MODIFICATION #2  
WEST LILAC ROAD OVER I-15 BRIDGE  
DEPARTMENT OF PUBLIC WORKS

**Request for a  
Modification to a Road Standard  
and/or to Project Conditions**

Project Number: TM 5571/5572 Date of Request: Sep. 12, 2012

## LILAC HILLS RANCH: 2.2C LIGHT COLLECTOR MODIFICATION TO ROAD STANDARDS

# ATTACHMENT 1

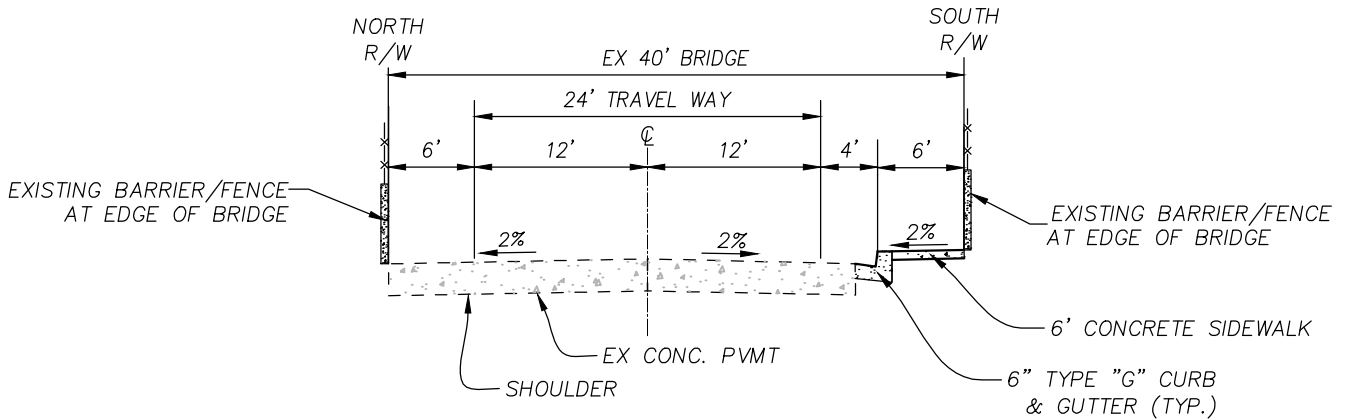
The standard road section for Light Collector Road 2.2C is 40'-54' wide curb to curb  
width on 64'-78' r/w with a minimum design speed of 40 mph. The requested modification  
to the road standard is to require no widening of the existing 40' wide West lilac Road  
bridge over I-15 and allow only re-striping and the addition of curb, gutter and sidewalk  
on one side of the road (see attachment 1).

The existing 40' wide bridge section has a 24' travel way with 8' shoulders on each  
side. A proposed widening of the bridge would be extremely expensive, extremely  
disruptive to anyone that uses West Lilac Road & I-15, and would alter the beauty and  
historic nature of the bridge (see attachment 2). The modified road would also allow  
for safer pedestrian traffic over the bridge.
